**APPLICATION FOR PERMISSION UNDER SECTION 16 TOWN PLANNING
APPLICATION FOR PROPOSED MINOR RELAXATION OF PLOT RATIO RESTRICTION
FOR PERMITTED FLAT WITH SHOP AND SERVICES AND SOCIAL WELFARE
FACILITY (RESIDENTIAL CARE HOME(S) FOR THE ELDERLY) IN "RESIDENTIAL
(GROUP A)" ZONE IN LOT NO. 3678 in D.D. 120, YUEN LONG, NEW TERRITORIES**

Town Planning Application No. A/YL/319 – Submission of Further Information (3)

Proposed Minor Relaxation of Plot Ratio Restriction for Permitted Flat with Shop and Services and Social Welfare Facility (Residential Care Home for the Elderly) Uses in “Residential (Group A)” Zone at Lot 3678 in D.D. 120, Yuen Long, New Territories (Application No. A/YL/319)

Departmental Comments (Email from Planning Department dated 14.6.2024, 19.6.2024 & 3.7.2024)	
Departmental Comments	Response
<u>1. Chief Town Planner/Urban Design & Landscape (CTP/UD&L), Planning Department (14.6.2024)</u>

PROPOSED LANDSCAPE PLAN

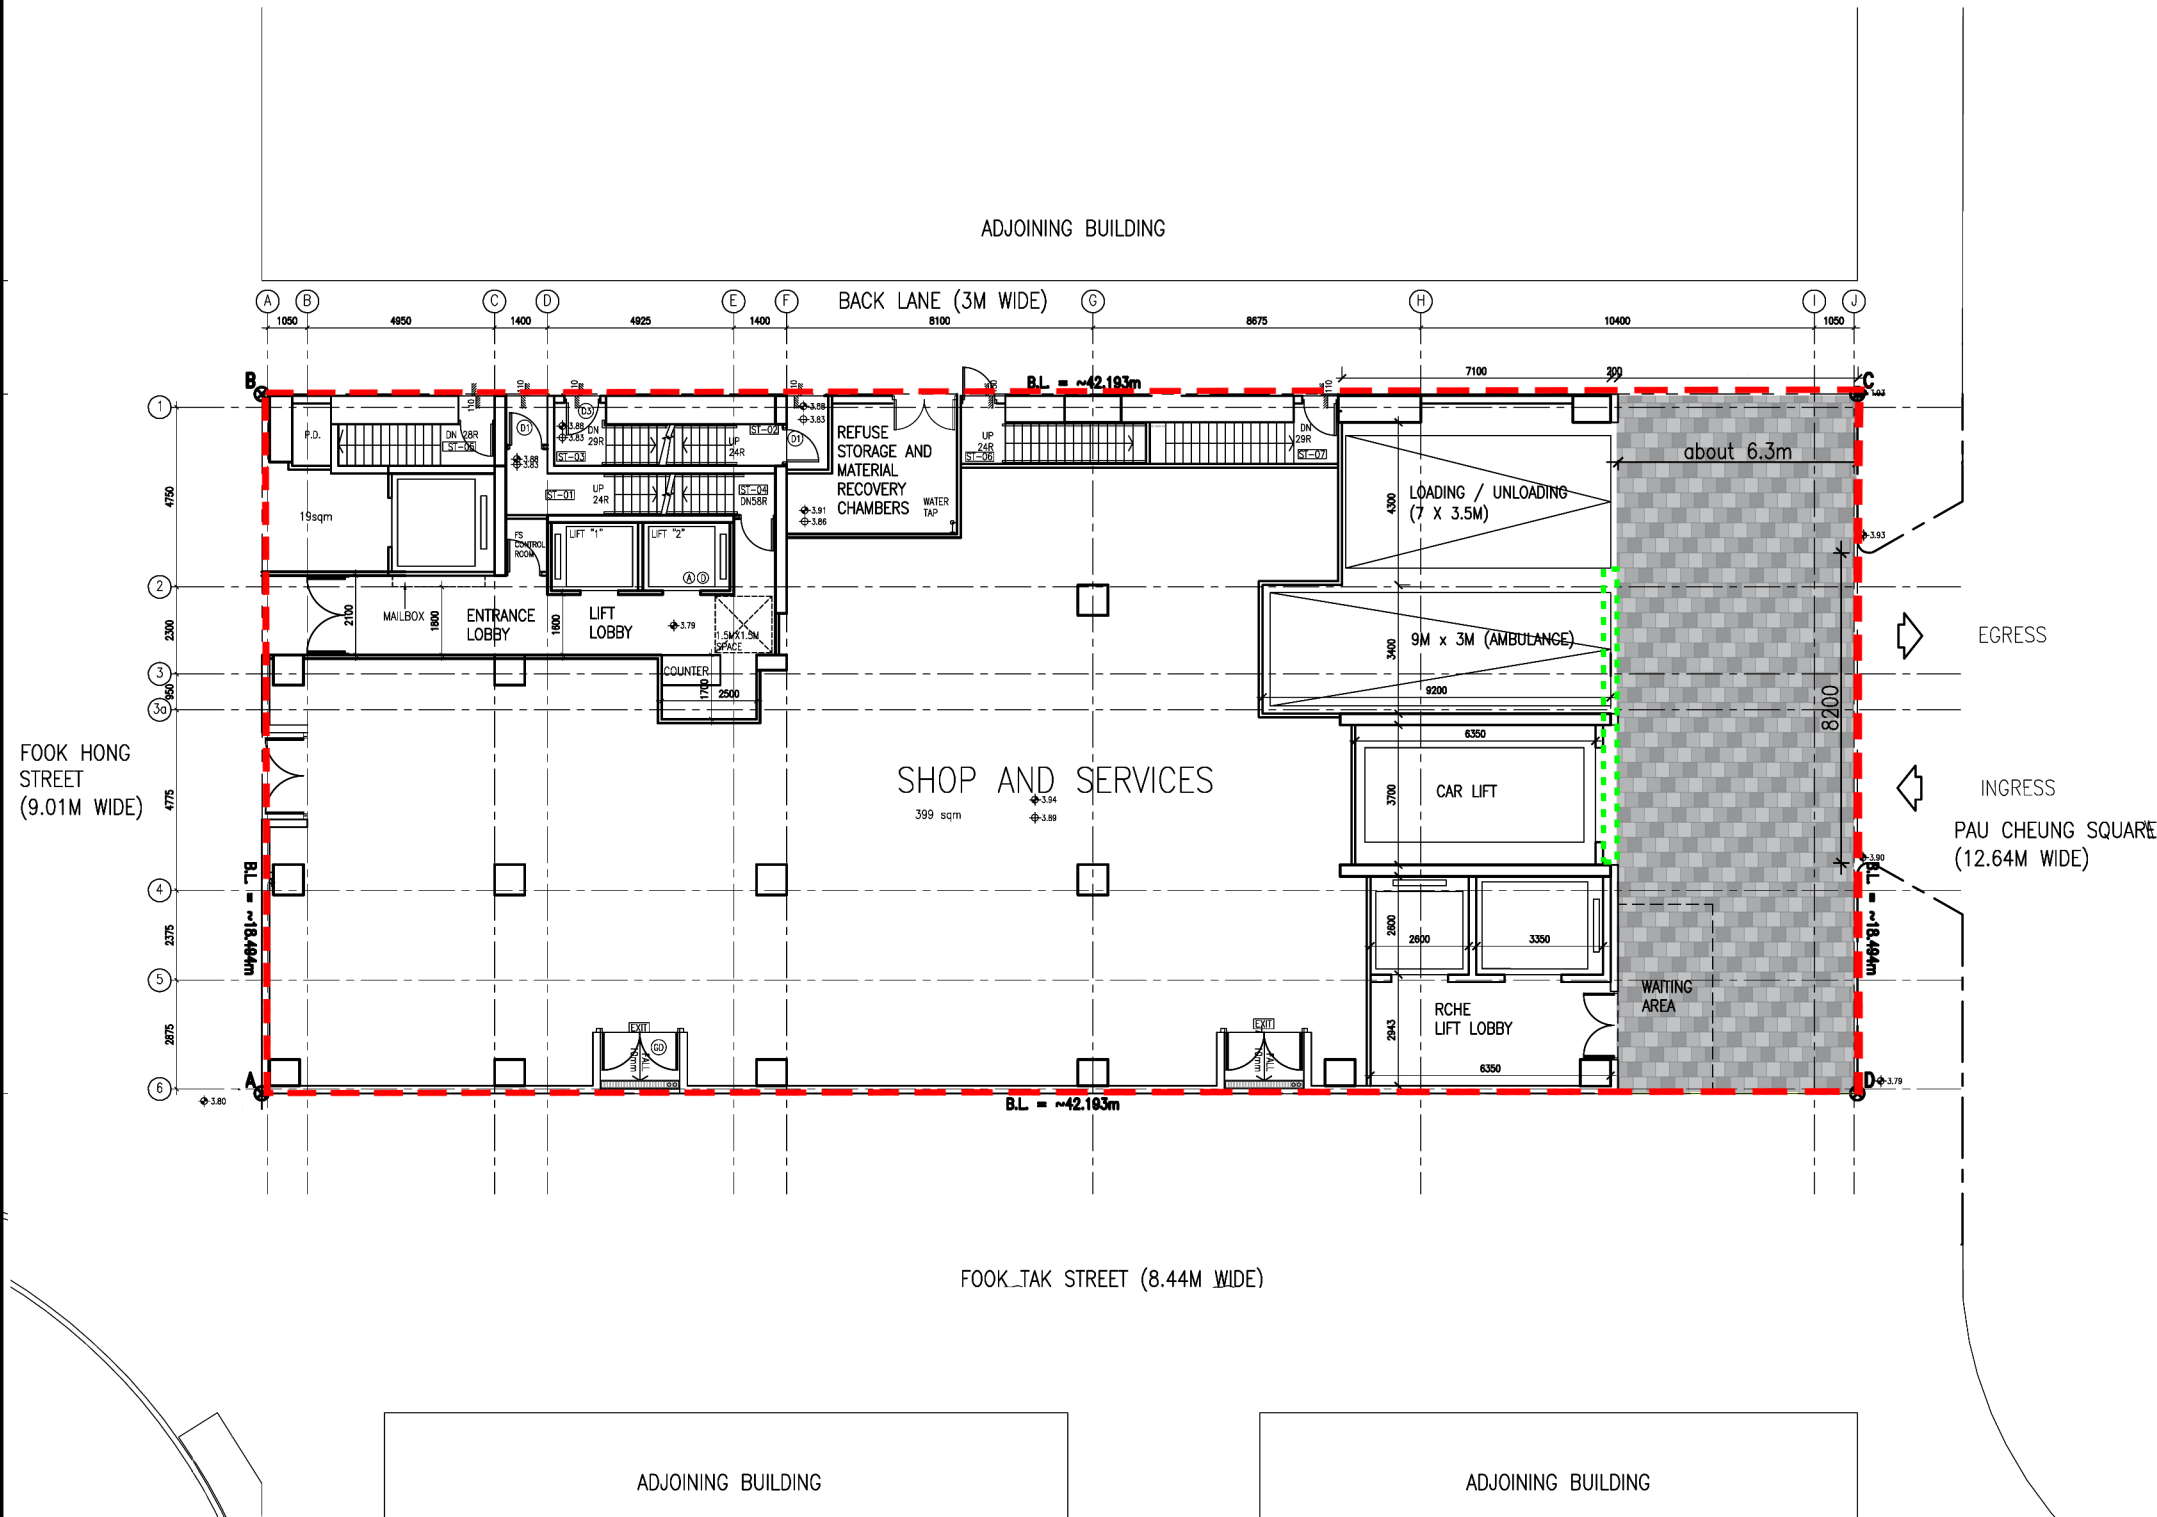
b) Please indicate the location of the proposed vertical greening on the landscape plan.	Please find the location of the proposed vertical greening in Appendix 3 of the Landscape Proposal (Attachment 1), subject to detailed design stage.

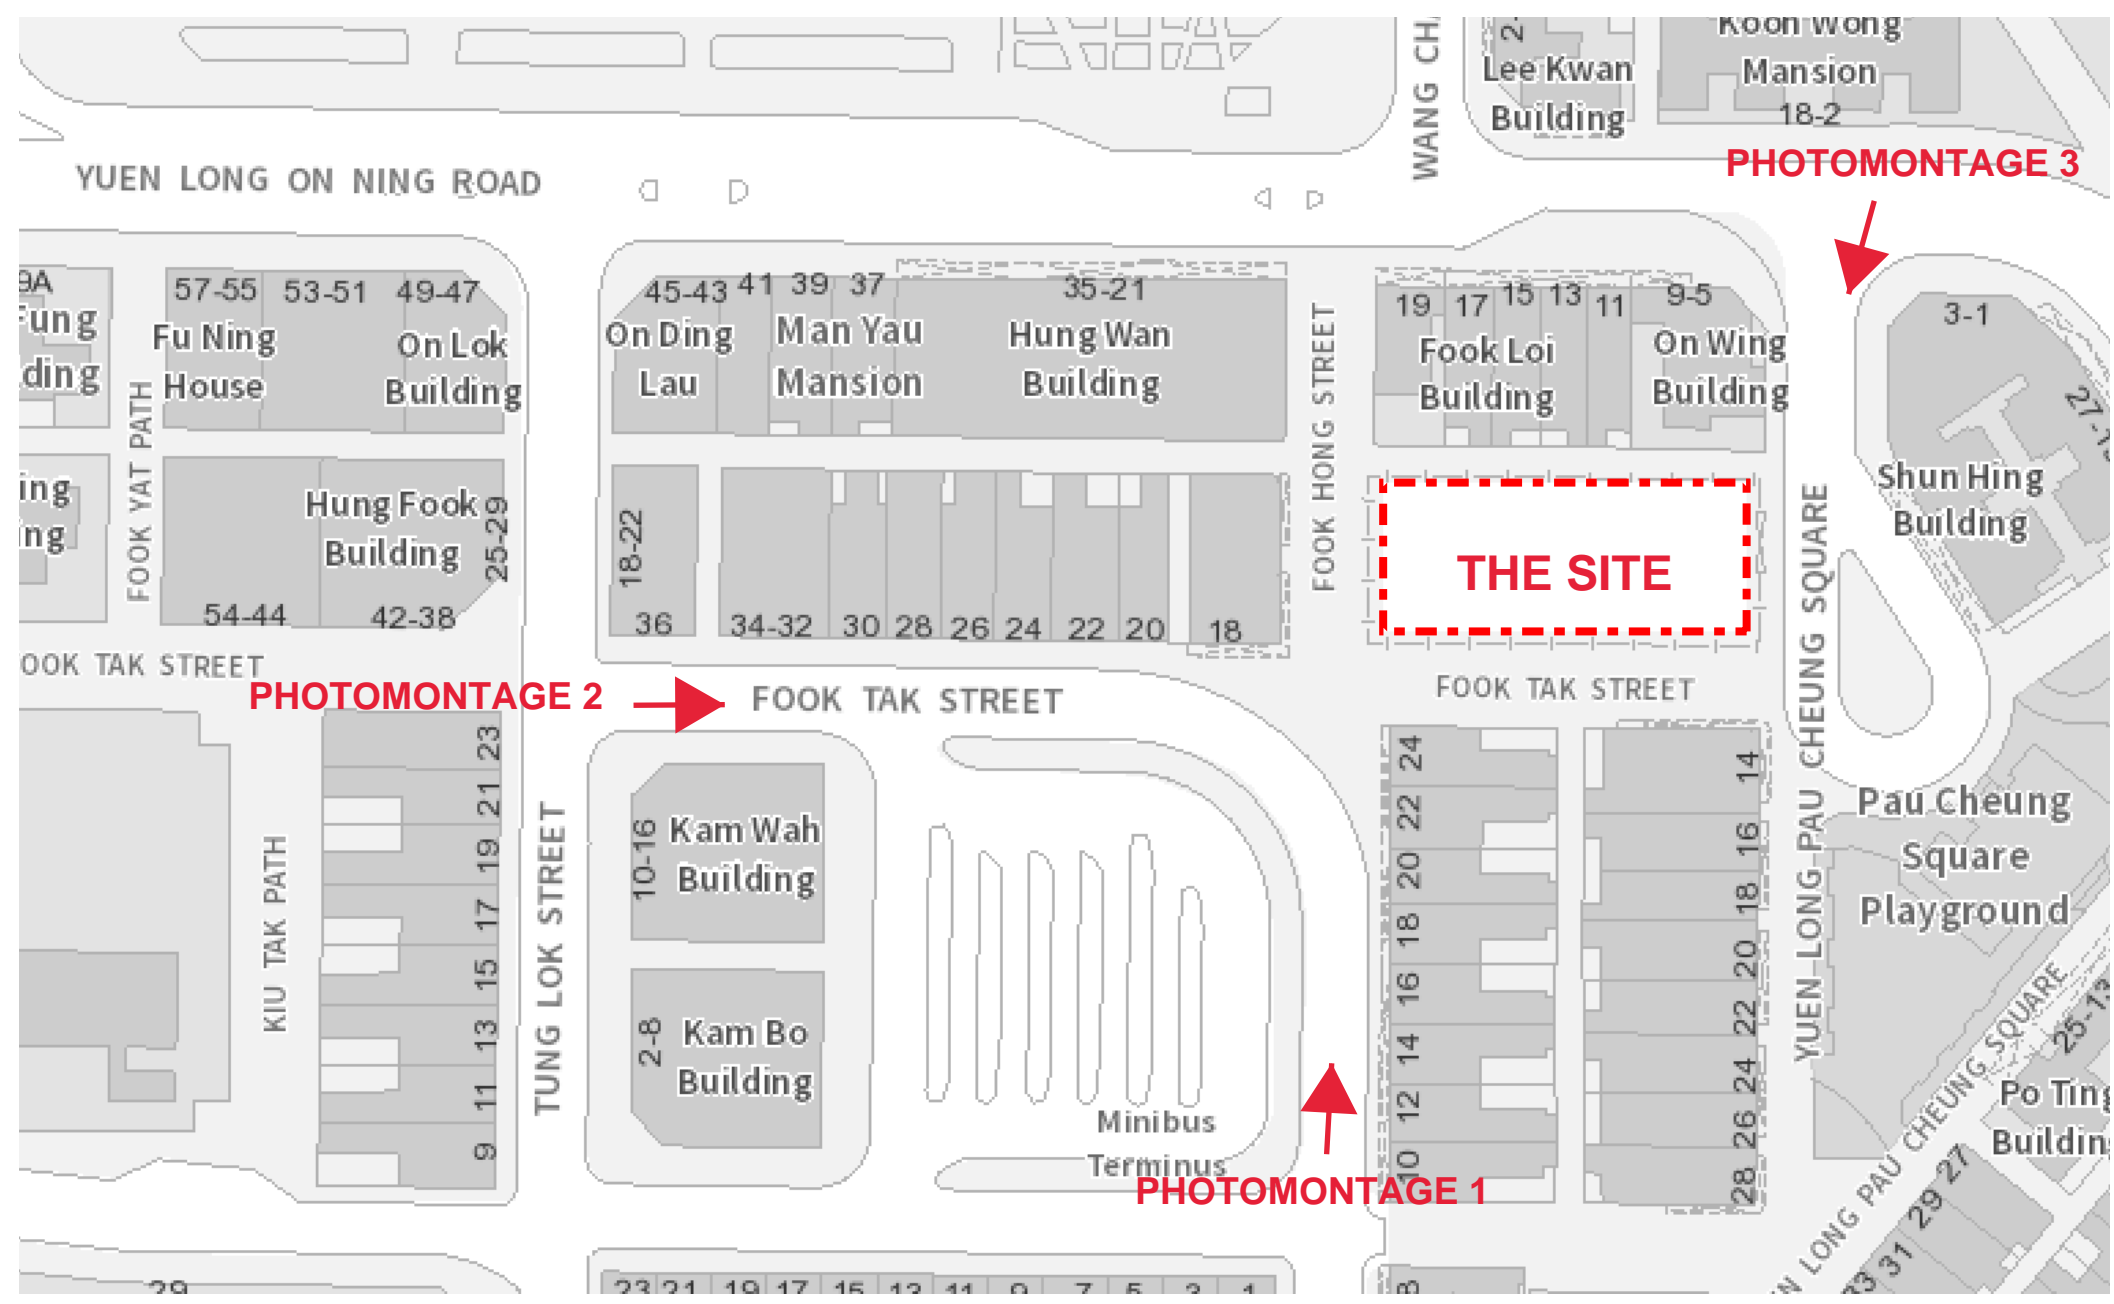
<p><u>4. Chief Town Planner/Urban Design & Landscape (CTP/UD&L), Planning Department (3.7.2024)</u></p>	
<p>a) With the photos seem to be distorted, and with its semi-transparent presentation of the proposed development (in that the buildings and sky view behind are still visible with the proposed development in place), the photomontages submitted may not be regarded as proper and plain illustrations of the proposed development.</p>	<p>Noted. Please refer to the photomontages in Attachment 4 which shows a clear view of the proposed development.</p>
<p>b) According to the preliminary checking based on the existing available information and in view of the surrounding building heights, it seems that the proposed development should appear to be shorter at VP1 and VP2; and wider and slightly shorter at VP3.</p>	<p>Noted. The building heights of the proposed development in the photomontages (Attachment 4) have been revised.</p>

<p><u>5. District Planning Officer/Tuen Mun and Yuen Long West (DPO/TM&YLW), Planning Department (3.7.2024)</u></p>	
<p>a) Please provide a location plan indicating all photo taking points of the photomontages of the proposed development.</p>	<p>Please refer to a location point of viewpoint in Attachment 4.</p>
